1 Products affected

| Product Change Notification | | | | | PCN - Change of potting material | | |
| owner | creation date | release date | released by | change order | rev | page | D10-068-482 |

| Current product appearance | New product appearance |

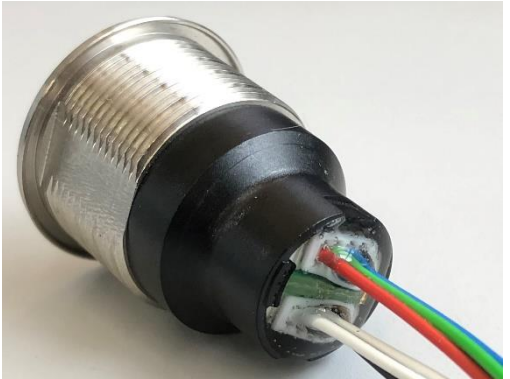
- Change of potting material. The color of the new material is transparent. The color of the current material is blue.
